SERVICE BULLETIN

Reference:	342-49-049 – SERVICE BULLETIN
Title:	Update of removal and installation procedures following the release of SB 342-49-048
Issue number:	001
Issue Date:	27-apr-2023

This Service Bulletin (SB) is applicable to all APU power plant fitted on Leonardo Helicopters AW189/AW149 helicopters.

Some procedures need to be updated with regard to the new combustor casing design, which modified the locking of the ignition and main manifolds' burners, igniter plugs and drain valve. The impacted procedures, updated in this Service Bulletin, are the following:

Figure 15: Temperature Probe T4-1 - Installation procedure (sheet 1 of 2)

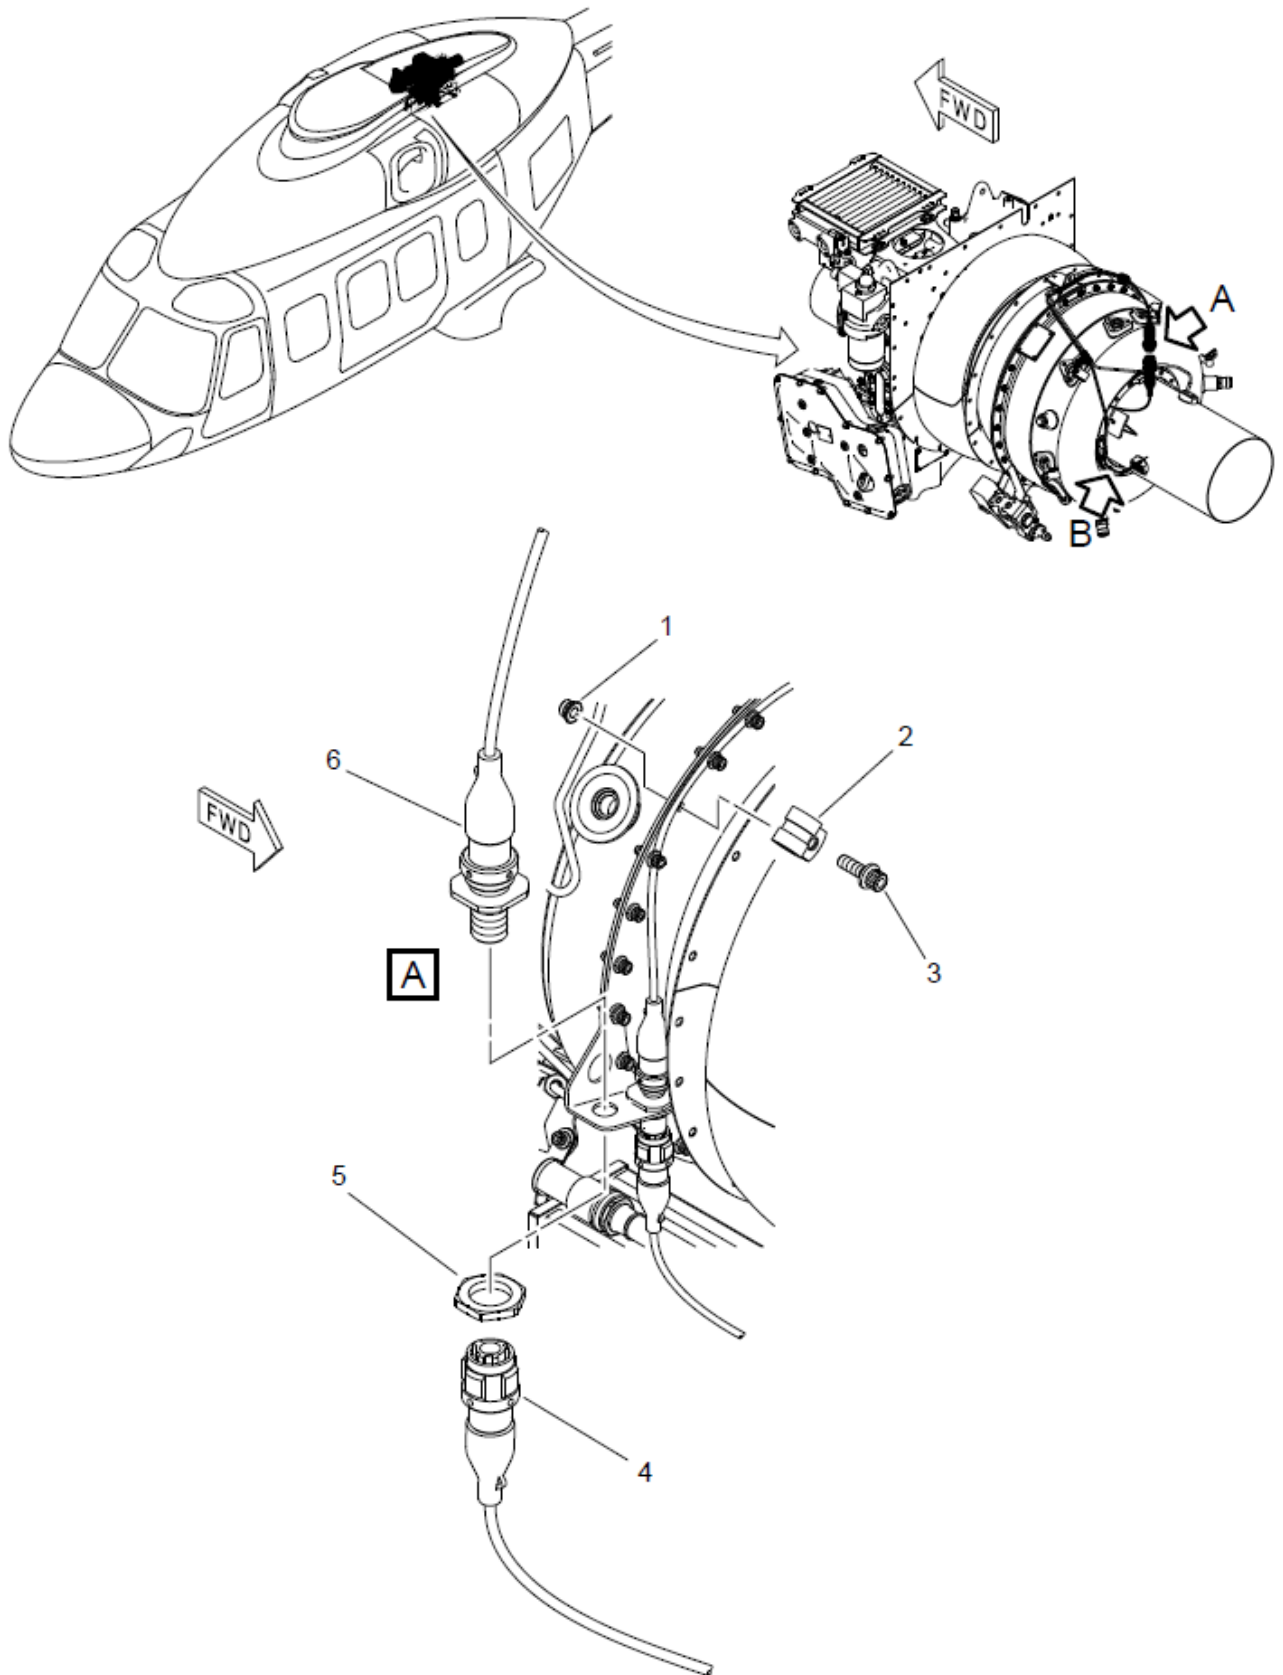
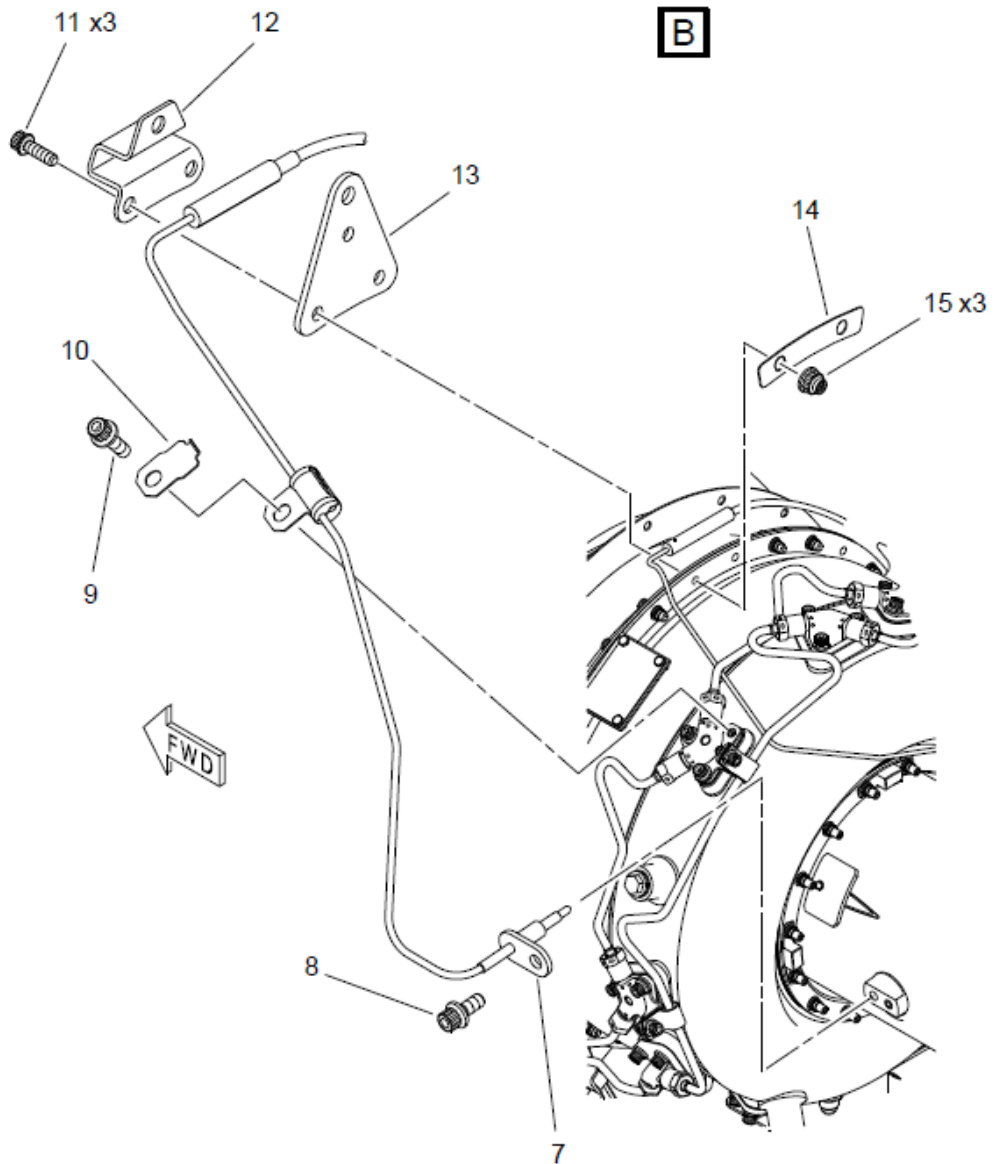
12. Installation of the Screw (9) if the APU is a post-modification SB 342-49-048 configuration:

20. If the APU is a post-modification SB 342-49-048 configuration, lock the Screw (9) with the other screw used to attach the burner with Lockwire.

Figure 16: Temperature Probe T4-2 - Removal procedure (sheet 1 of 2)

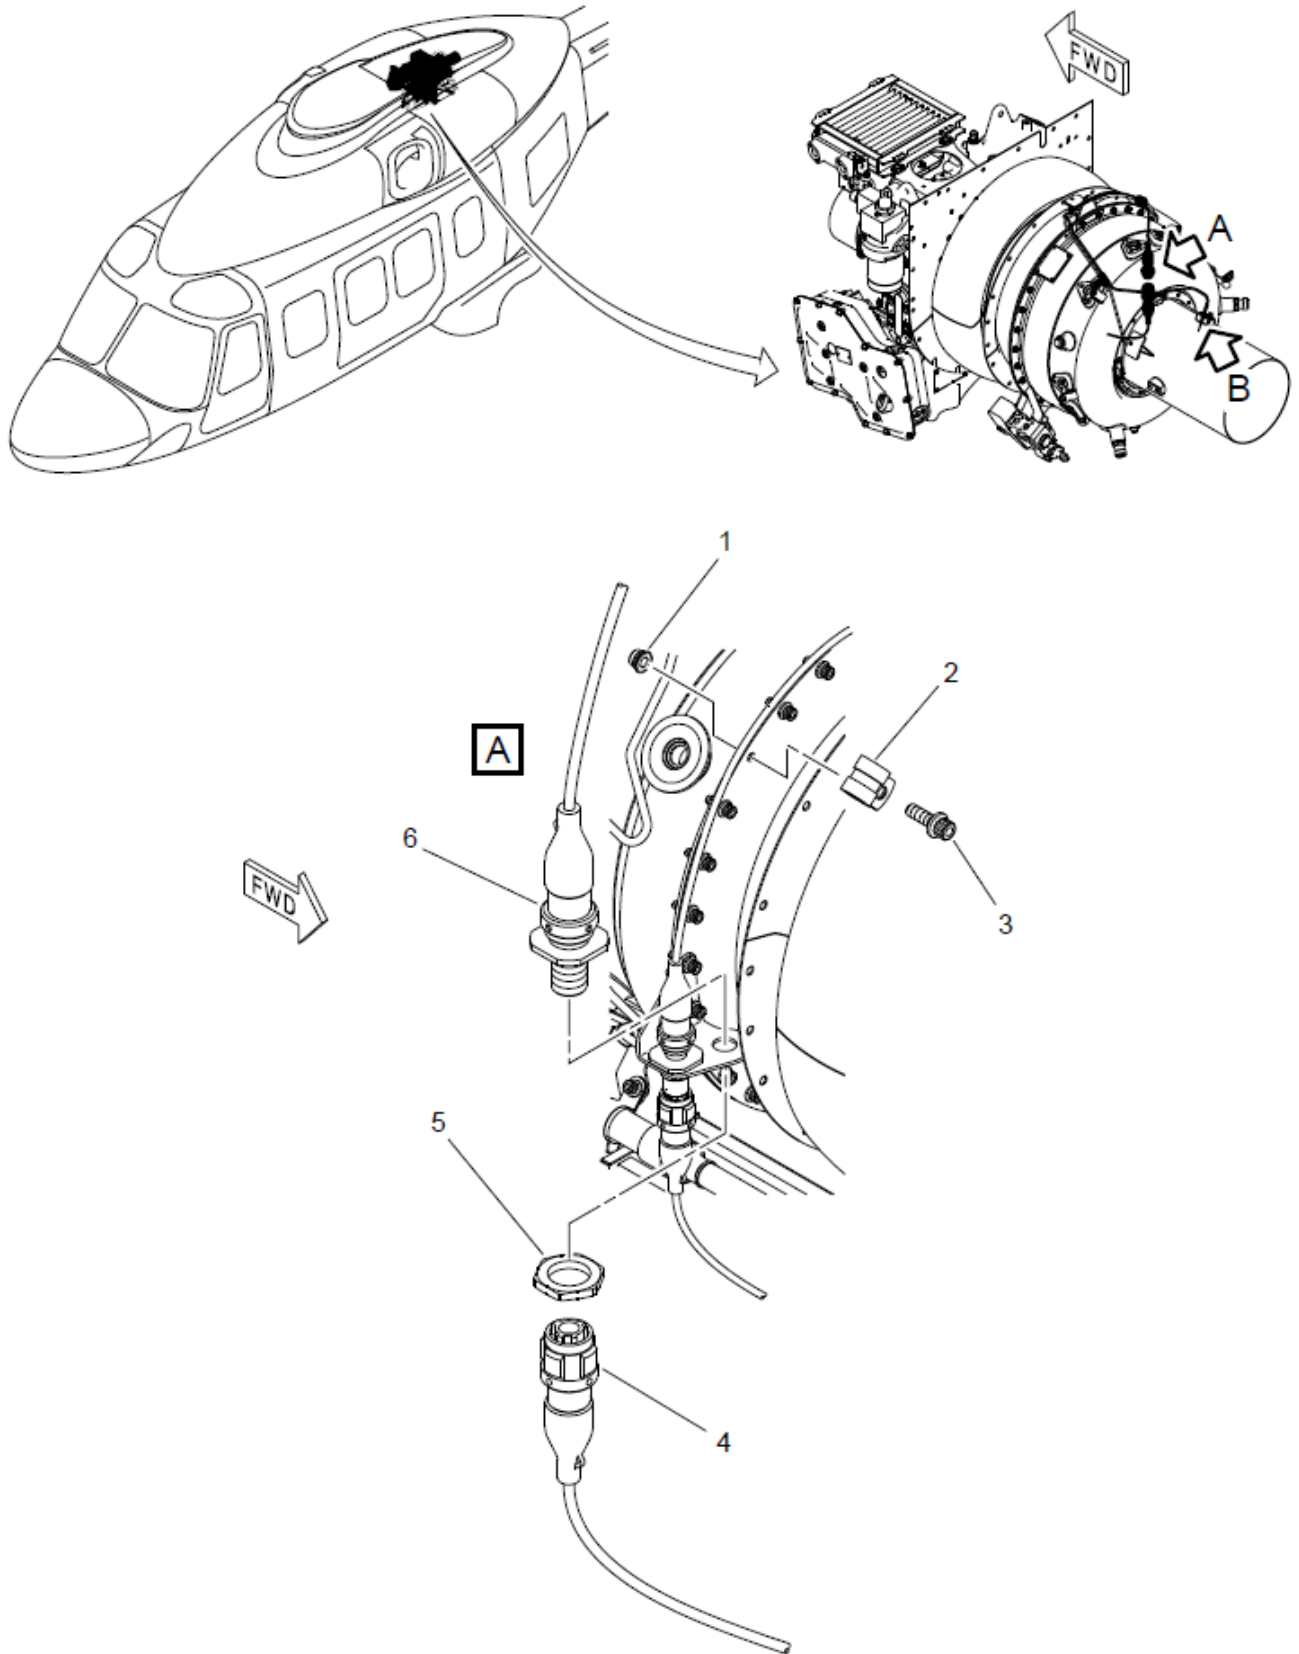
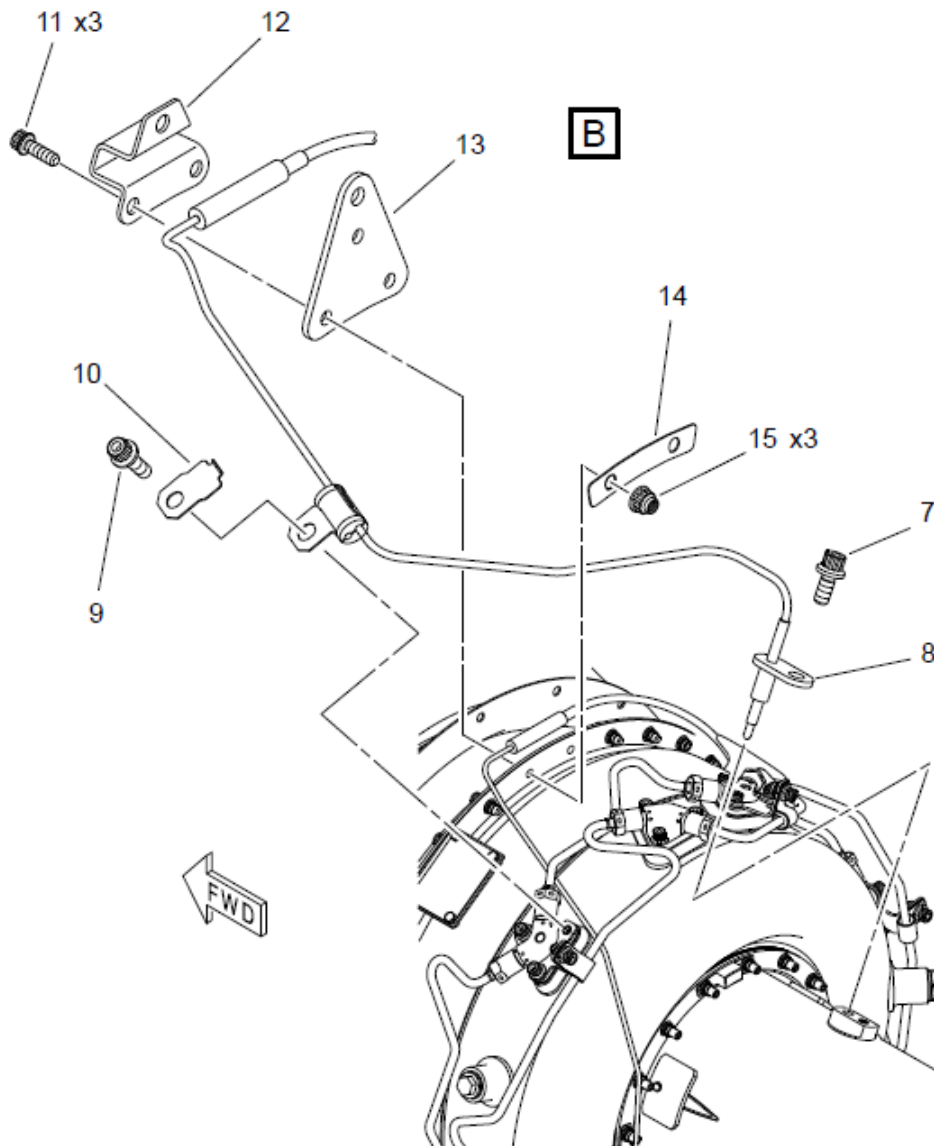
Cut and remove the safety wire from the screw (9).

12. Remove and discard the screw (9) of the clamp (10).

13. Remove the clamp (10).

14. Remove and discard the screw (7) of the temperature probe T4-2 (8).
15. Remove the temperature probe T4-2 (8).

Figure 17: Temperature Probe T4-2 - Installation procedure (sheet 1 of 2)

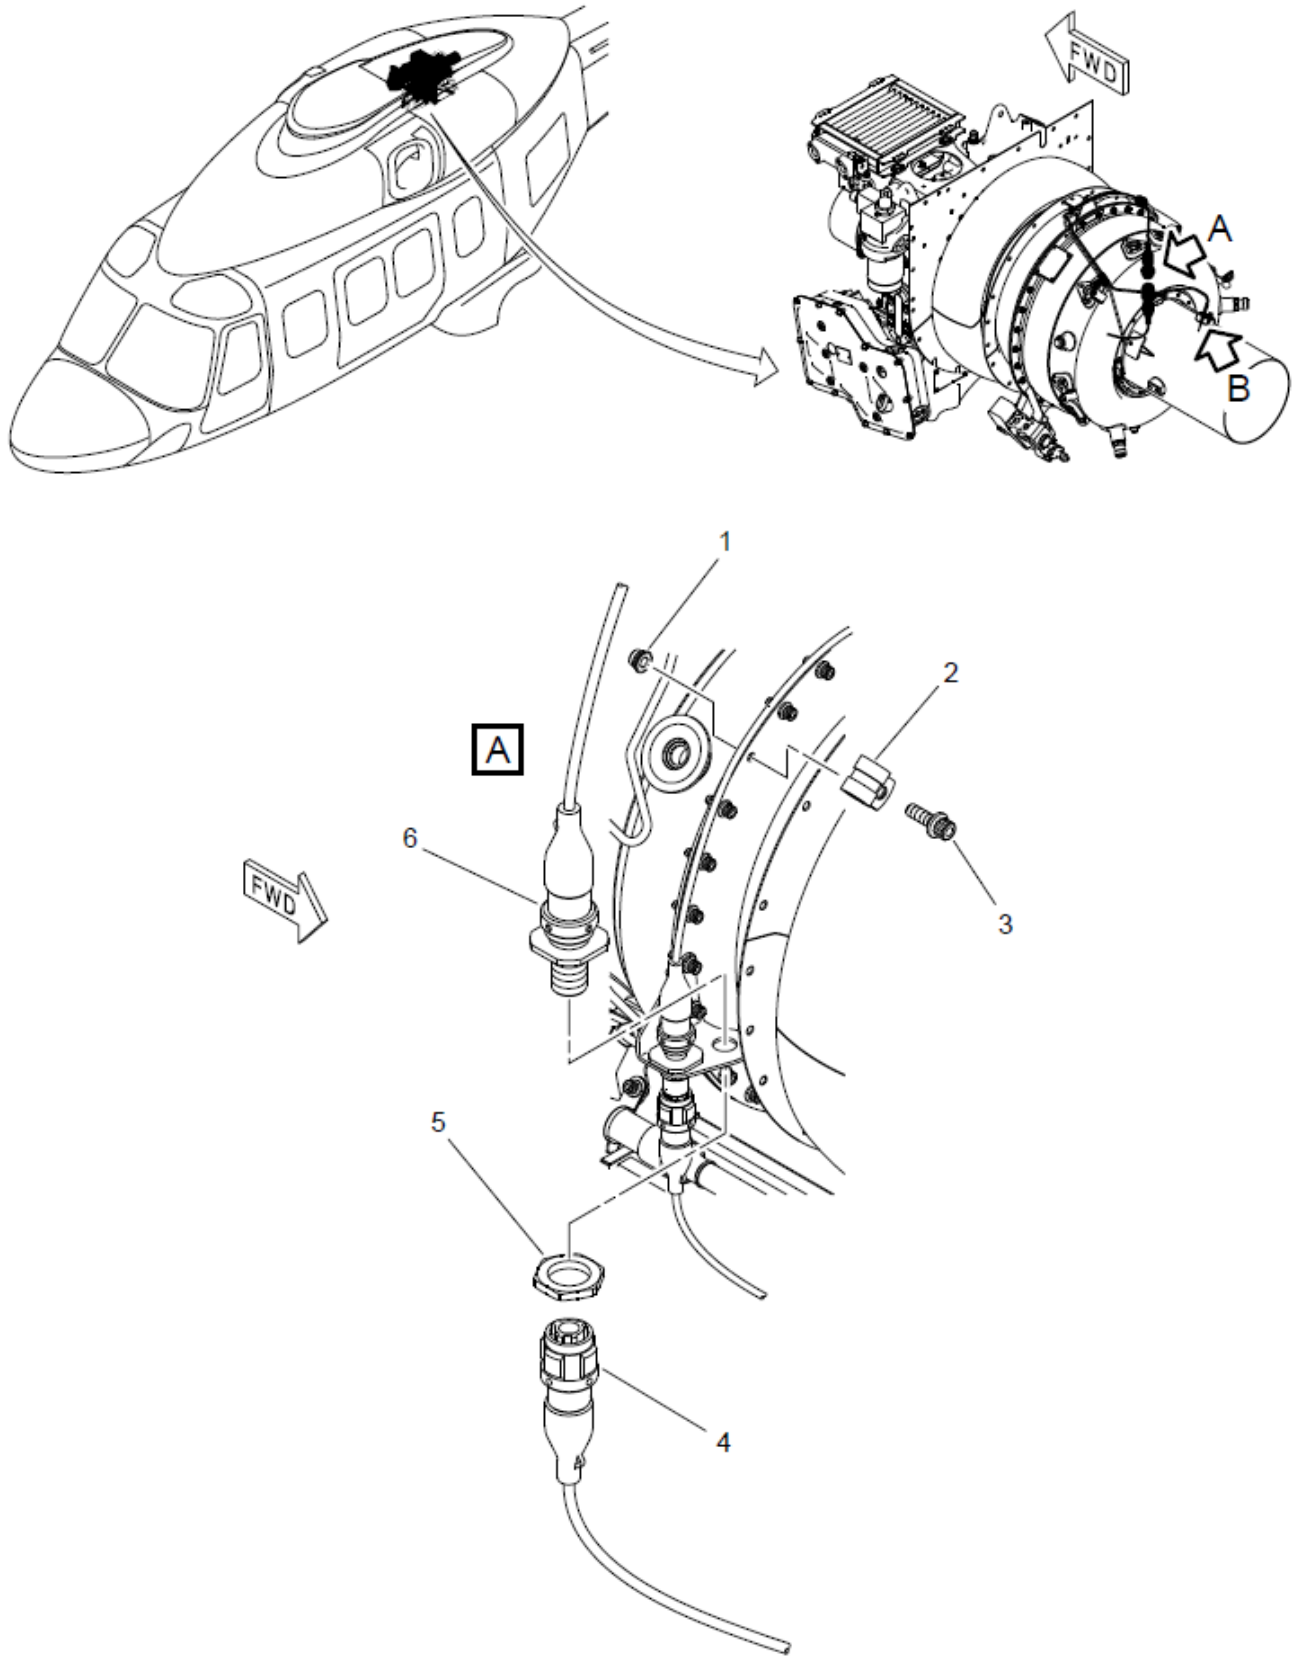
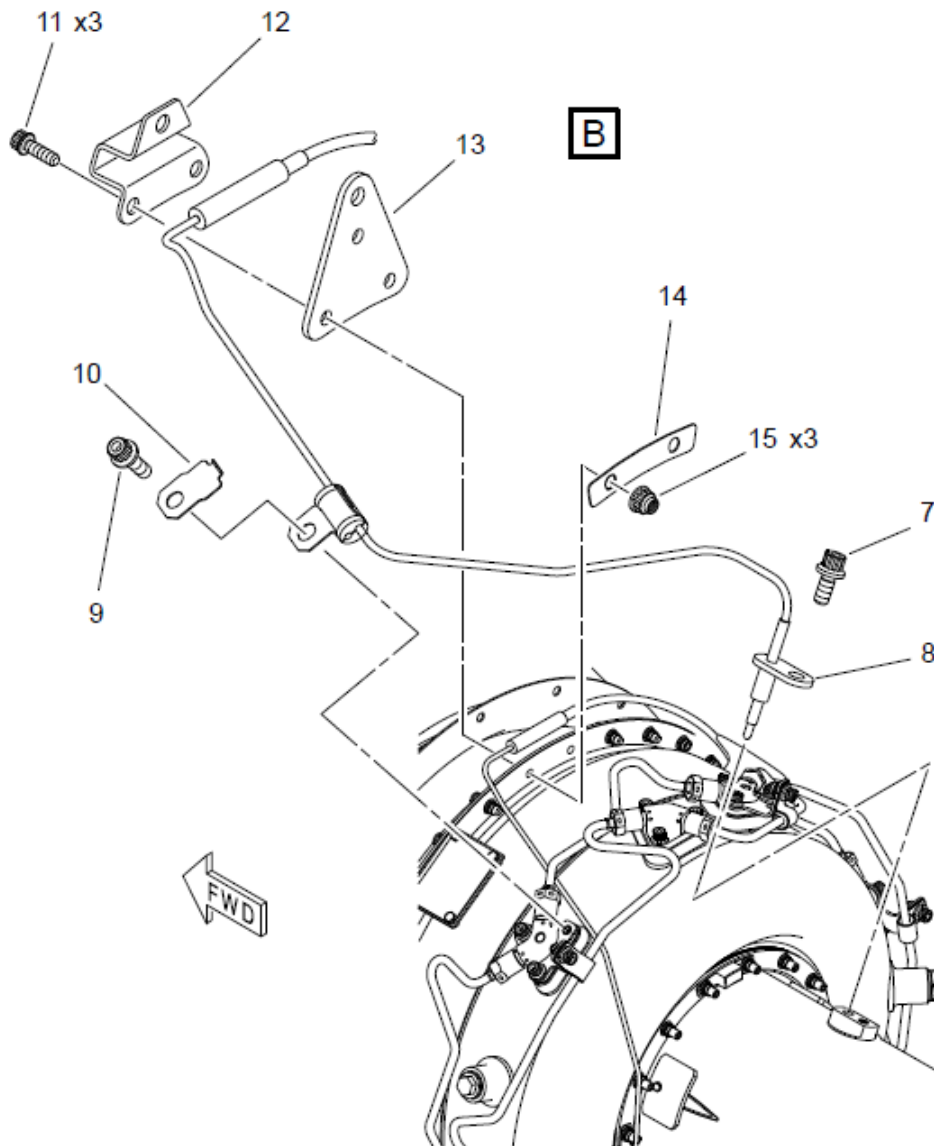
12. Installation of the Screw (9) if the APU is a post-modification SB 342-49-048 configuration:

20. If the APU is a post-modification SB 342-49-048 configuration, lock the Screw (9) with the other screw used to attach the burner with Lockwire.
